# City of New Bedford

## STAFF REPORT

**Case #2017.20: CERTIFICATE OF APROPRIATENESS**

24 Centre Street  
(Map 53, Lot 28)

Proposed Location for Second Driveway on East Side of  
24 Centre Street

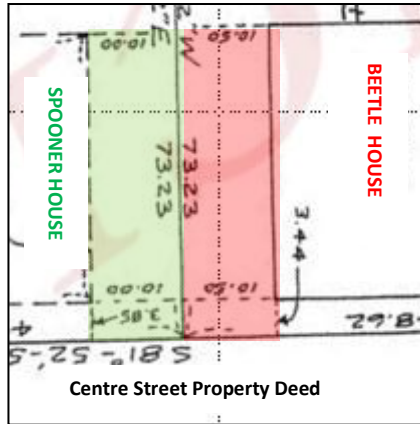
DEPARTMENT OF INFRASTRUCTURE: The City's Department of Infrastructure (DPI) has reviewed the proposal and conducted a site visit. DPI recommends widening the shared driveway apron between the two properties from the current 10' width to a maximum of 18'. DPI will be responsible for the relocation of the streetlamp a few feet westerly of its current location to accommodate the driveway apron widening and has provided the applicant with the cost estimate for this service. The property owner is responsible for the curb widening, and in this case the sidewalk material alterations. The City requires the property owner to provide a City approved bonded contractor to perform this work and the contractor is required to work closely with the DPI's engineers.

The proposed removal of the retaining wall and widening of the driveway apron will not greatly impact the visual aesthetic of the property or the District. Staff recommends the approval of the request, however acute care is required in the execution of the work to ensure that the original sidewalk materials are retained and altered correctly to continue the appropriate sidewalk design of granite runners, cobblestones, bricks and Belgian blocks.
